22087-01-001

**Clonrooske Housing Development,
Portlaoise**

ROAD SAFETY AUDIT STAGE 1 / 2

2.1 Problem

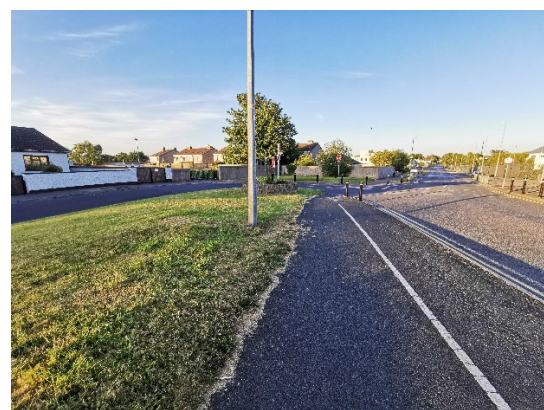
The existing access road to Clonrooske View housing estate bends through a right angle on approach to its junction with Harpers Lane.

The intended road into the proposed development takes access from that bend on Clonrooske View Road resulting in an awkward junction layout such that drivers may not be clear how the junction is intended to operate. No regulatory markings are shown to be provided to govern junction priority. Drivers on Clonrooske View Road are likely to assume that they retain priority, but as a result of the unusual way in which the arms of the junction align there is a risk that drivers entering or exiting the proposed development might not yield to traffic on Clonrooske View Road. This could result in turning collisions at the access to the proposed development.

If feasible, amend the junction layout to make it clear which arms are intended to have priority. At minimum, provide STOP road markings and a STOP sign on minor arms, and mark a centreline on the mainline through the junction.

2.1	yes	yes	Recommendation implemented on attached Architects drawing PA 002	-
2.2	no		The road is 5.5m wide which is normal for a cul-de-sac. Drivers not remaining in lane when rounding the bend is more a driver issue than a road issue. If such vehicles could come into conflict with vehicles exiting the new development, surely they are also at risk of coming into conflict with vehicles coming in the opposite direction, exiting the cul-de-sac. Maybe the road needs a center-line marking for this initial section to encourage drivers to stay on their correct side of the road. We can check the swept path of the road but this road is outside of the site boundary and therefore any issue with the suitability of it for drivers to negotiate the bend should be address by the Local Authority Roads Division.	Noted

2.2 Problem

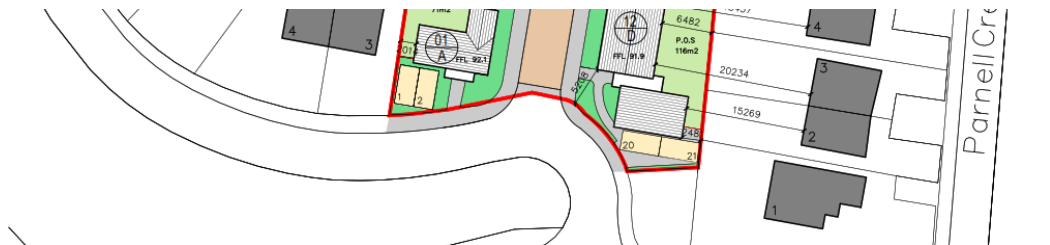
Due to the tight curvature on the access road to Clonrooske View, some vehicles do not remain in lane when rounding the bend. Such vehicles could come into conflict with vehicles existing the development.

Check the swept path of vehicles travelling to and from Clonrooske View and ensure that the road is of sufficient width on the bend so that vehicles can remain in lane.
